Material License: 04-35176-01E

Docket: 040-38378

Subject: PHILIPS LIGHTING TECHNOLOGIES INTERNATIONAL, REQUEST FOR
ADDITIONAL INFORMATION CONCERNING APPLICATION FOR AN
AMMENDMENT REGARDING NAME CHANGE TO LIGHTING
TECHNOLOGIES INTERNATIONAL

Figure 1

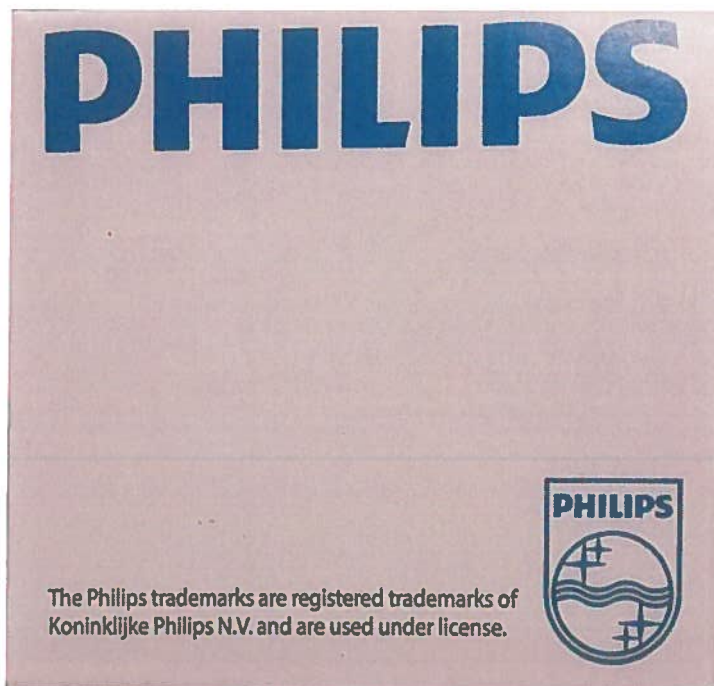
3. Provide the new label for the device indicating the new company name and the effective date of the label change.

Print added to the inner lamp box:

“The Philips trademarks are registered trademarks of Koninklijke Philips N.V and are used under license”
